Service Bulletin S/B 1012

8"x12" Lift Cylinders

HYD CYLIND AEO

PHOTO #1
CAP END RECESSED

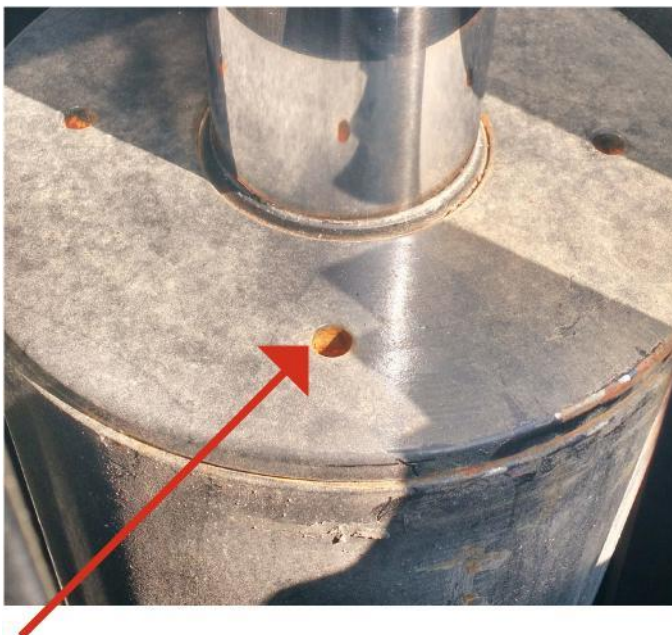
Photo 1 to the left depicts cylinders that **are not** affected by the issue that is the subject of this service bulletin. These cylinders, which do not need to be replaced, can be identified by the cap end of main housing recessed.

Photo 2 to the left depicts cylinders that **are** affected by the issue that is the subject of this service bulletin. These cylinders, which need to be replaced, can be identified by the cap end being flush to the outside of the main housing.

1. REMOVE ALL 8"x 12" BORE CYLINDERS FROM PMB.
2. CAP OFF HYDRAULIC LINES.
3. INSTALL NEW 8"x 12" BORE CYLINDERS SUPPLIED BY XL.
4. REFILL HYDRAULIC FLUID AND RUN CYLINDERS TO TEST FUNCTION.
5. PALLATIZE FAULTY CYLINDERS AND NOTIFY XL TO SCHEDULE RETURN SHIPMENT.
